Interactive comment on “Domestic wells have high probability of pumping septic tank leachate” by J. E. Horn and T. Harter

Anonymous Referee #2

Received and published: 24 October 2011

Fig. 1.

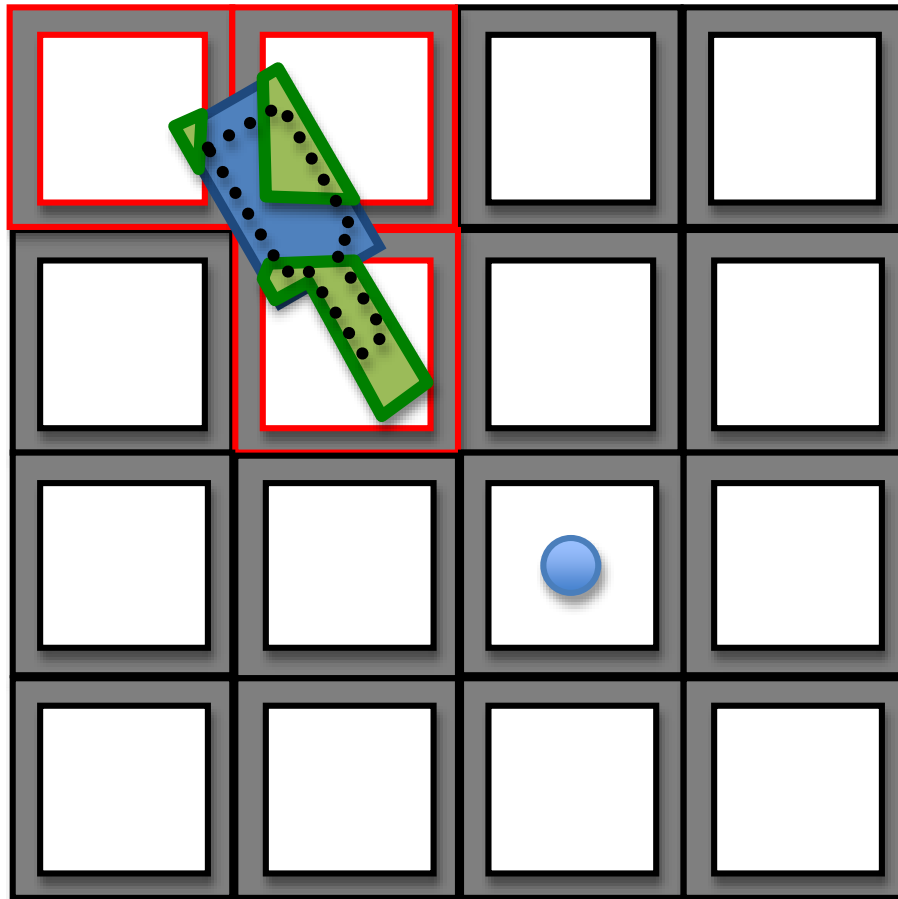
Figure 1 and 2 are not working as well to explain these ideas as they could. For instance, it would be easier to understand Figure 2 if the capture zones shown were the same relative scale as they are in Figure 1. It would also be very helpful to show Figure 2 at an expanded scale, which would allow the authors to show the full overlap of the capture zone across multiple lots. I've attached a different version of Figure 1 and 2 that I think captures the authors' intentions:

The original capture zone is shown as the dashed line. The capture zone "footprint" is shown as the solid shape. The cell array is shown, with buffers at the property boundaries grayed out. The red cells are those intersected by the capture zone footprint. The areas within the cells that are overlapped and are outside the buffer are shown in green. The areas in the footprint that cannot contain the center of a drain field are shown in blue. The probabilities per cell would be computed as the green area for each cell divided by the grey area for each cell.
